**RE: SAD 228, Lot 41B Block 6
6639 Sujeto Rd NW
Grading and Drainage Plan
Engineers Stamp Date 3/6/15 (D10D00M41B)**

GRADING AND DRAINAGE PLAN
LOT 41B, BLOCK 6, UNIT 18, VCS
ADDRESS: 6639 Suero Rd NW

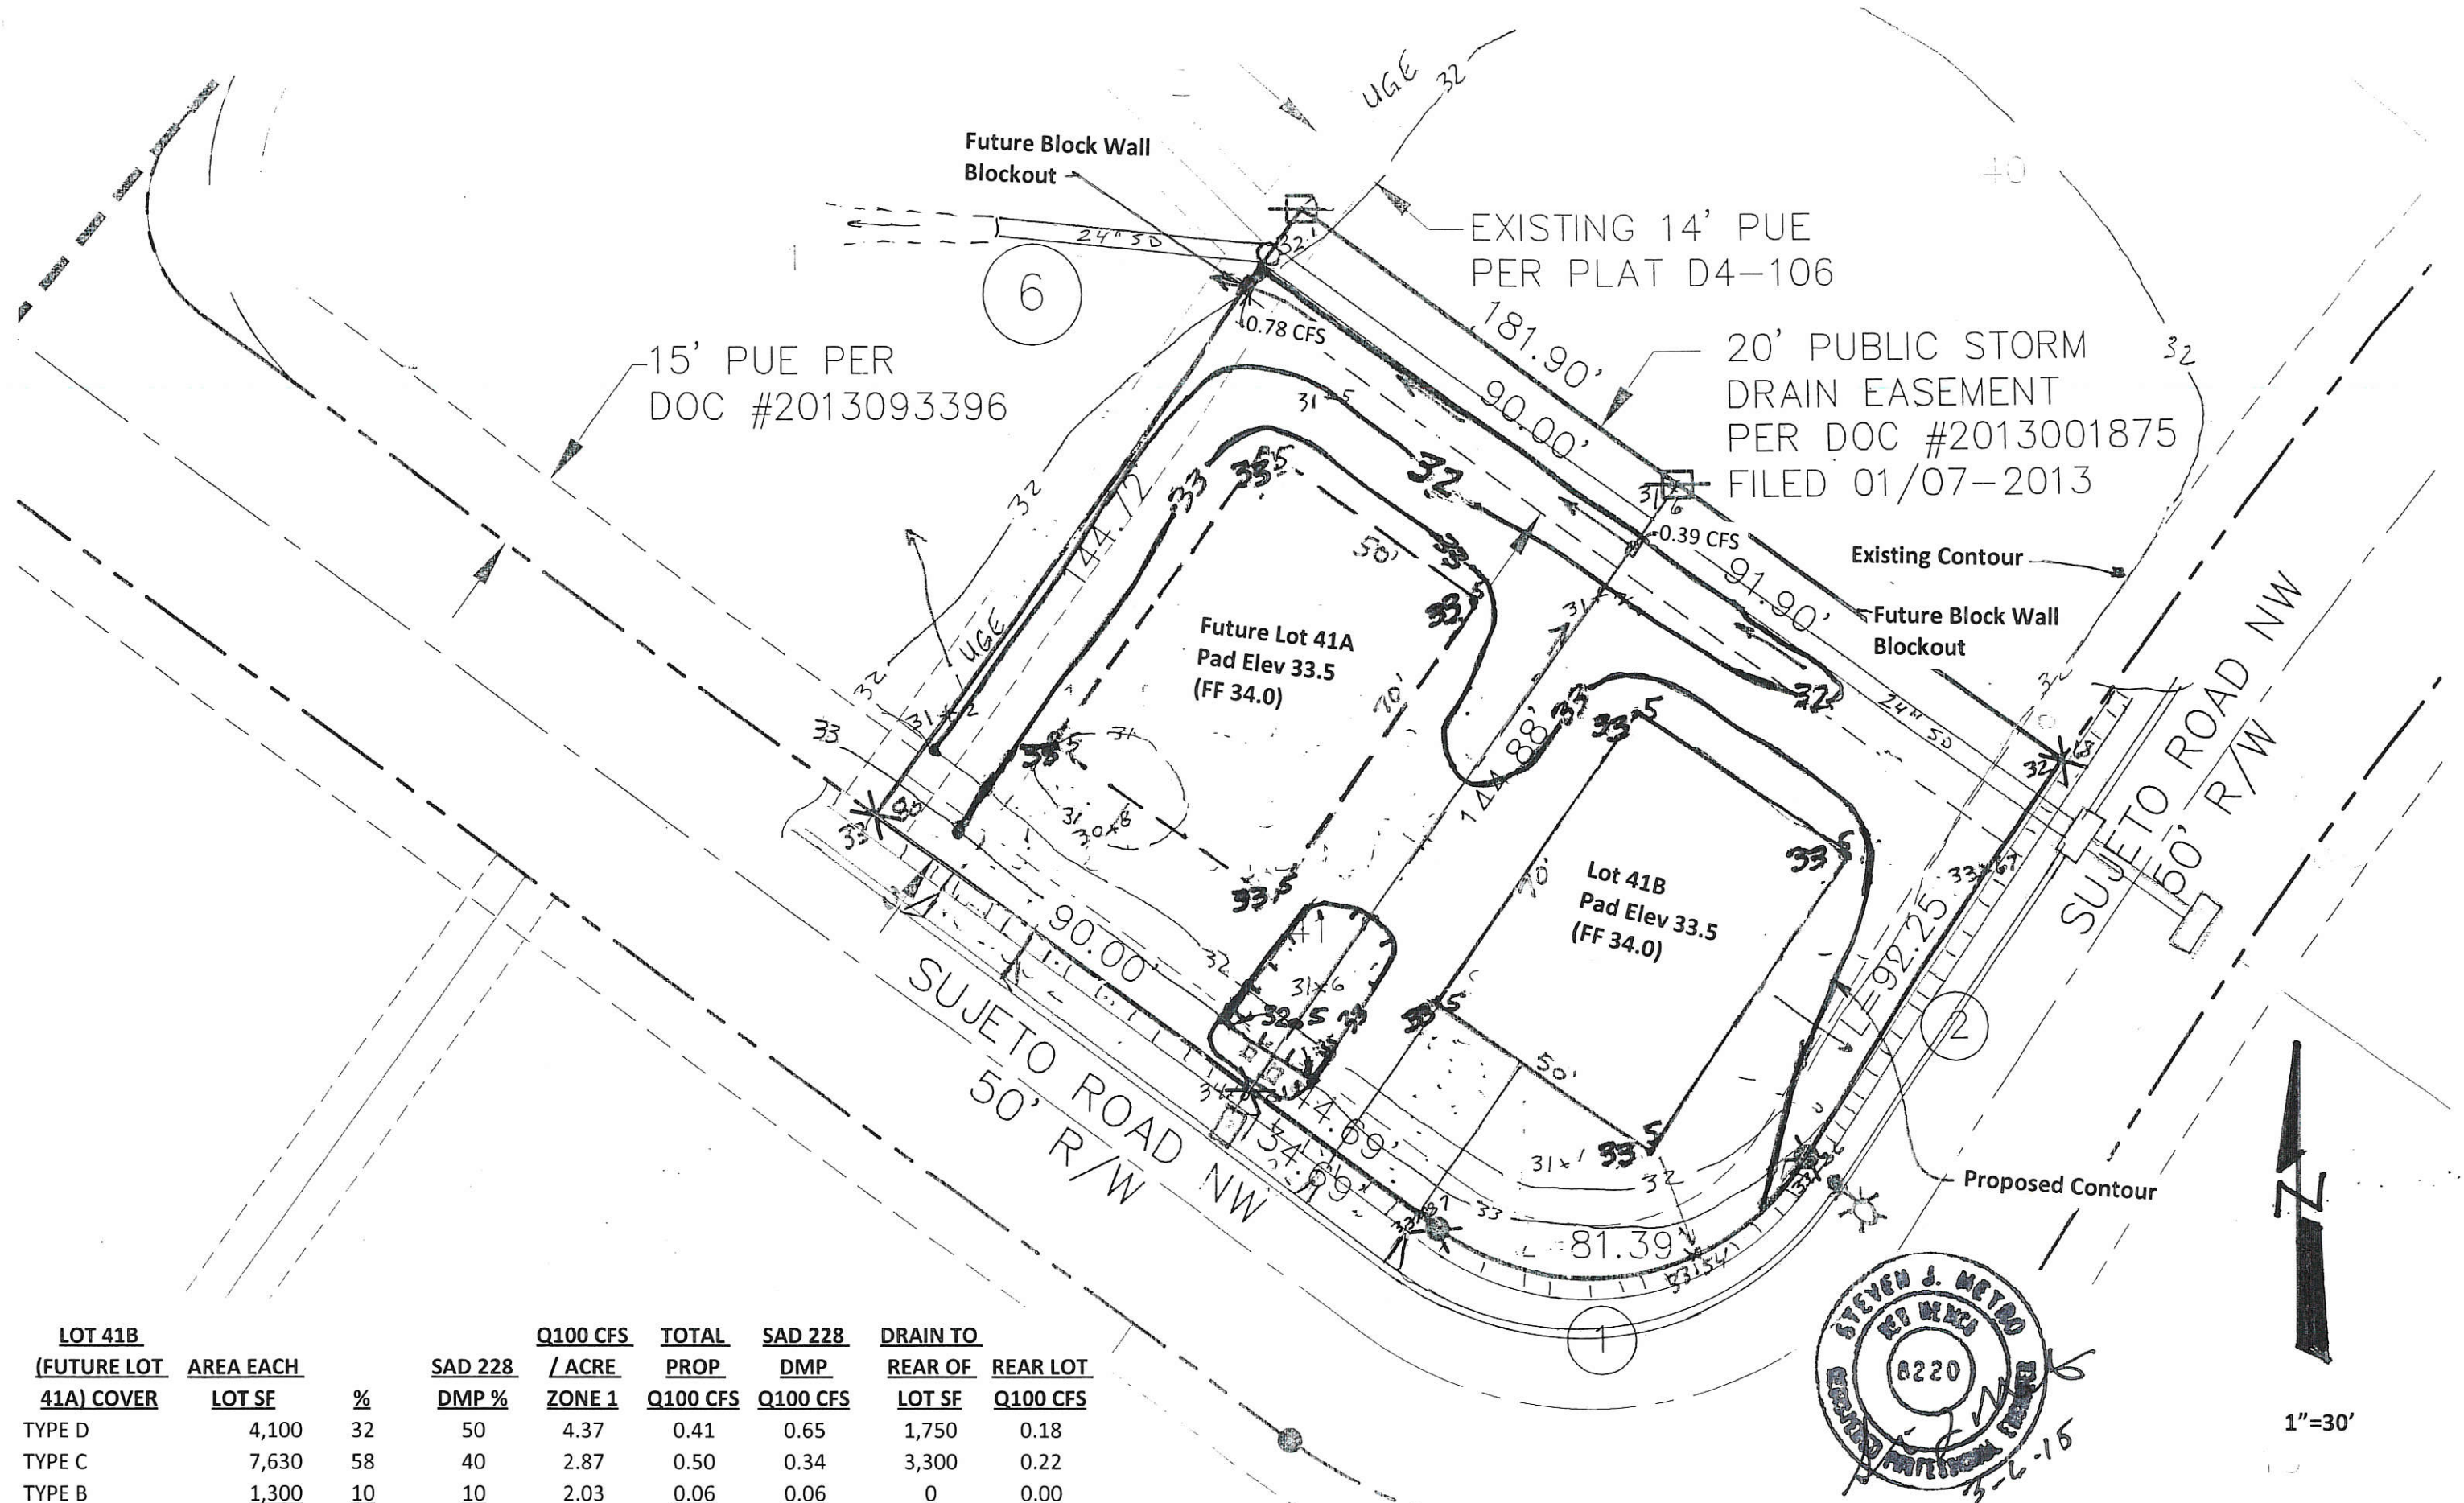
Based upon the information provided in your submittal received 3/6/2015, this plan is approved for Grading Permit and Building Permit.

Please attach a copy of this approved plan to the construction sets in the permitting process prior to sign-off by Hydrology.

Prior to Certificate of Occupancy release, Engineer Certification per the DPM checklist will be required.
